23043-01-001

St. John's Convent, New Street, Rathangan

# **ROAD SAFETY AUDIT STAGE 1 / 2**

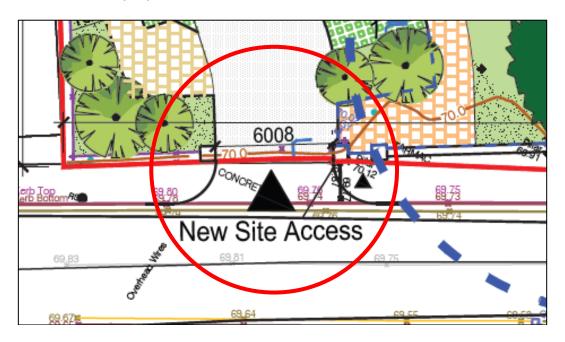
Intervisibility between drivers of vehicles exiting the proposed development and pedestrians travelling along the existing footpath may be restricted by the proposed boundary walls and piers either side of the access. A lack of adequate intervisibility at this location may contribute to a pedestrian collision at the proposed access.

Revise the layout to ensure that adequate intervisibility between drivers of vehicles exiting the proposed development and pedestrians travelling along the existing footpath is provided.

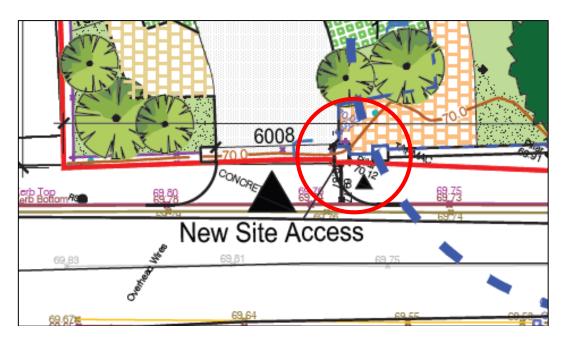
The proposed pedestrian access to the development from the R414 adjacent to the vehicular access appears to be narrow. As a result, mobility impaired pedestrians may not be able to use this access and instead access the proposed development via the vehicular access which would increase the risk of a collision at this location.

Ensure that the proposed pedestrian access is sufficiently wide to cater for mobility impaired pedestrians.

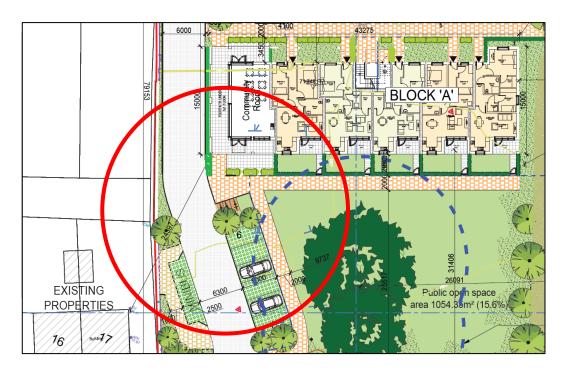
A minibus set-down area is proposed within the development on the west side of the access road with a footpath to the rear of the set-down area. However, the main footpath linking to the housing units within the development is located on the east side of the access road and an appropriate link to this footpath is not shown to be provided from the minibus et-down area. A lack of an appropriate footpath link may result in pedestrians travelling along the access road where they would be at an increased risk of being struck by a passing vehicle.

Provide an adequate footpath link from the minibus set-down to the proposed footpath on the east side of the access road.

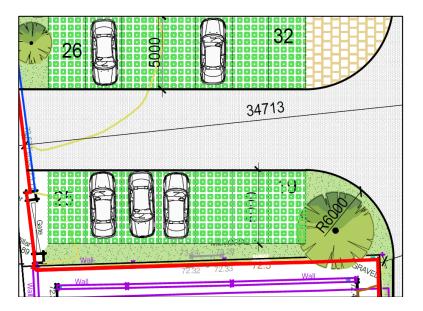
At the proposed access the kerbline is shown to be returned with priority given to drivers of vehicles entering and exiting at the access. Dropped kerbs and tactile paving are not shown to be provided to cater for mobility impaired pedestrians crossing at the proposed access. A lack of adequate pedestrian facilities may increase collision risk at this location.

In conjunction with recommendation 2.4 above, provide priority to pedestrians at the access. Alternatively, provide dropped kerbs and tactile paving either side of the access.
